Duane Arnold Energy Center Docket No. 50-331 Renewed Facility Operating License No. DPR-49

License Amendment Request (TSCR-168), Application to Revise Technical Specifications to Adopt TSTF-542, "Reactor Pressure Vessel Water Inventory Control"

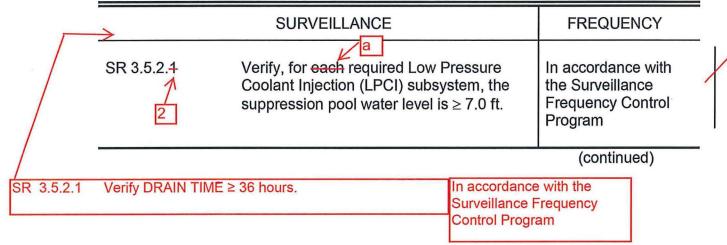
CONDITION	R	EQUIRED ACTION	COMPLETION TIME
Ð.	Required Action C.2 and associated Completion Time not met.	D.1	Initiate action to restore Secondary Containment to OPERABLE status.	Immediately
INSERT D (3.5.2)		AND		
		D.2	Initiate action to restore one Standby Gas Treatment subsystem to OPERABLE status.	Immediately
		AND		
		D.3	Initiate action to restore isolation capability in each required Secondary Containment penetration flow path not isolated.	Immediately

D. DRAIN TIME < 8 hours.	D.1	 NOTE	Immediately
	AND		
	D.2	Initiate action to establish secondary containment boundary.	Immediately
	<u>AND</u>		
	D.3	Initiate action to isolate each secondary containment penetration flow path or verify it can be manually isolated from the control room.	Immediately
	<u>AND</u>		
	D.4	Initiate action to verify one standby gas treatment subsystem is capable of being placed in operation.	Immediately
E. Required Action and associated Completion Time of Condition C or D not met.	E.1	Initiate action to restore DRAIN TIME to ≥ 36 hours.	Immediately
<u>OR</u>			
DRAIN TIME < 1 hour.

<u>SR 3.5.2.6</u>

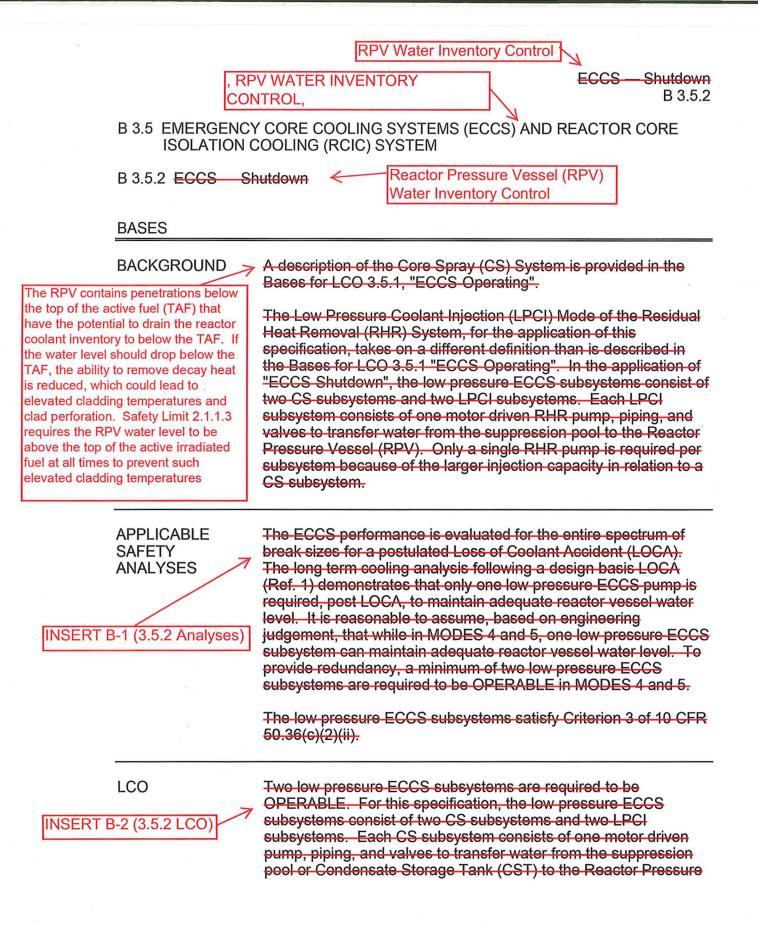
INSERT B-5 (SR 3.5.2.6-8)

Verifying that the required ECCS injection/spray subsystem can be manually started and operate for at least 10 minutes demonstrates that the subsystem is available to mitigate a draining event. Testing the ECCS injection/spray subsystem through the recirculation line is necessary to avoid overfilling the refueling cavity. The minimum operating time of 10 minutes was based on engineering judgment. The Surveillance Frequency is controlled under the Surveillance Frequency Control Program.

RPV Water Inventory Control

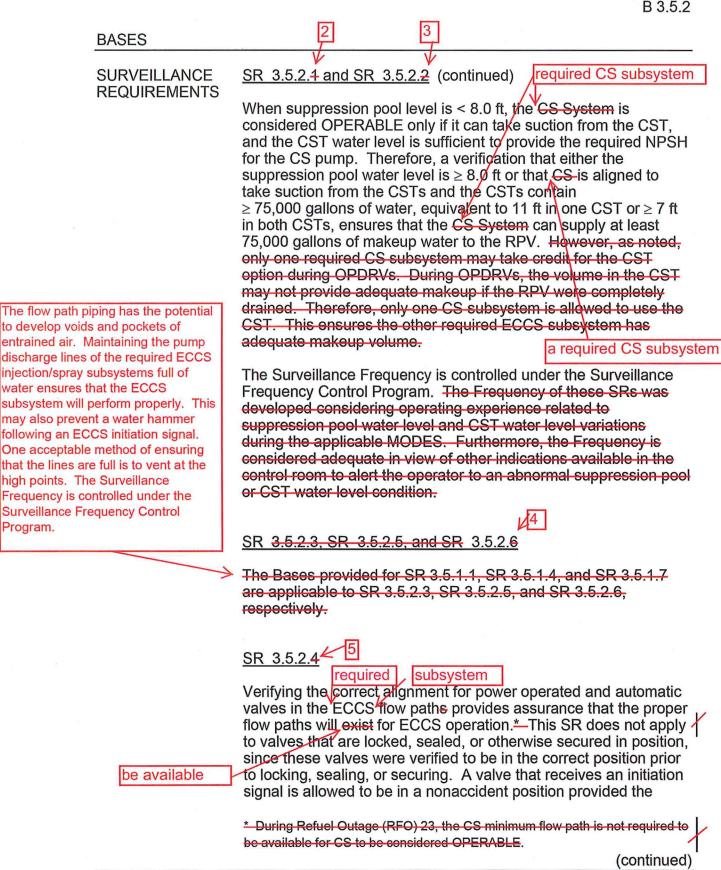
The 4 hour Completion Time to restore at least one low pressure ECCS subsystem to OPERABLE status ensures that prompt action will be taken to provide the required cooling capacity or to initiate actions to place the plant in a condition that minimizes any potential fission product release to the environment.
INSERT B-4 (SR3.5.2.1)	\rightarrow μ^2 μ^3
SURVEILLANCE REQUIREMENT	
subsystem pump	The minimum water level of 7.0 ft required for the suppression pool is periodically verified to ensure that the suppression pool will provide adequate Net Positive Suction Head (NPSH) for the LPCI System pumps, recirculation volume, and vortex prevention. With the suppression pool water level less than the required limit, the LPCI subsystem(s) is (are) inoperable.
	is

RPV Water Inventory Control ECCS — Shutdown B 3.5.2
BASES	5
SURVEILLANCE REQUIREMENTS	<u>SR 3.5.2.4</u> (continued)
	valve will automatically reposition in the proper stroke time. This SR does not require any testing or valve manipulation; rather, it involves verification that those valves capable of potentially being mispositioned are in the correct position. This SR does not apply to manual valves unless the valves are being manipulated to serve as all or part of a system vent flow path opened under administrative control, as described in the SR Note (and Bases paragraph below). In this case, the SR Note allows the licensee to credit administratively controlled manual action to close the system vent flow path in order to maintain system Operability during system venting and performance of the gas accumulation SR. This SR does not apply to valves that cannot be inadvertently misaligned, such as check valves. The Surveillance Frequency is controlled under the Surveillance Frequency Control Program. The Frequency is appropriate because the valves are operated under procedural control and the probability of their being mispositioned during this time period is low.
